3VH4720 Vertical door track

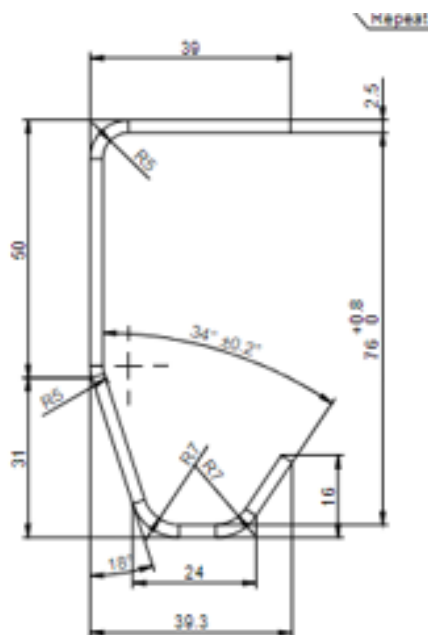
| - Commercial description | : Replaces the 13155 track |
| - Technical description | : Improved quality. The new shape has a better roller surface and has more room for movement of the roller. Bolted connection can be applied if desired. |
